Pentium® II Xeon™ Processor Specification Update

Release Date: April 1999

Order Number: 243776-012

The Pentium® II Xeon™ processor may contain design defects or errors known as errata which may cause the product to deviate from published specifications. Current characterized errata are documented in this Specification Update.

Figure 1. An Example of Microcontroller Driven Thermal Management

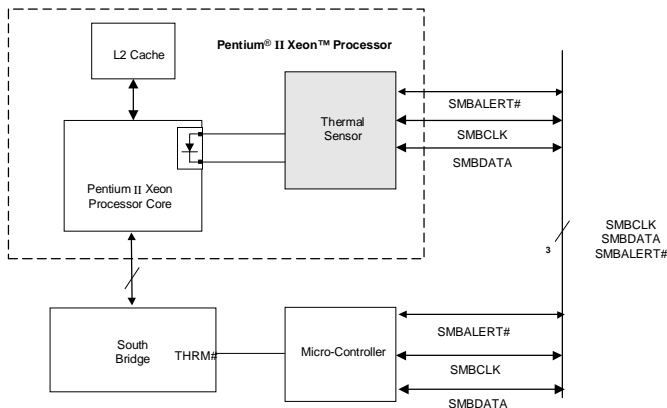
D30. Thermal Sensor May Assert SMBALERT# Incorrectly

PROBLEM: The Pentium II Xeon processor has a thermal sensor that monitors the processor core's temperature. The thermal sensor asserts SMBALERT# if the processor temperature exceeds the temperature limits set in the Alarm Threshold Registers (T_{HIGH} , T_{LOW}). It also sets the corresponding Status Register bits to identify the cause of the interrupt. Figure 1 gives one example of the how the SMBALERT# signal could be used in a system.

Under the conditions described below, the thermal sensor incorrectly generates the SMBALERT# interrupt. All of the following conditions must be met to trigger a false interrupt:

WORKAROUND: Three different (mutually exclusive) workarounds are possible:

1. Before servicing an interrupt from the thermal sensor, read and compare the processor thermal reading with the threshold limits (T_{HIGH} or T_{LOW}). Figures 2 and 3 provide basic flowcharts for the implementation of this workaround in an interrupt driven system.
2. If the firmware implemented polls the Status Register only, then before taking any action, re-read the temperature register and do a comparison with the alarm threshold limits (T_{HIGH} or T_{LOW}) to determine if the value is actually still within the temperature window.
3. Use a temperature polling scheme to monitor the processor temperature.
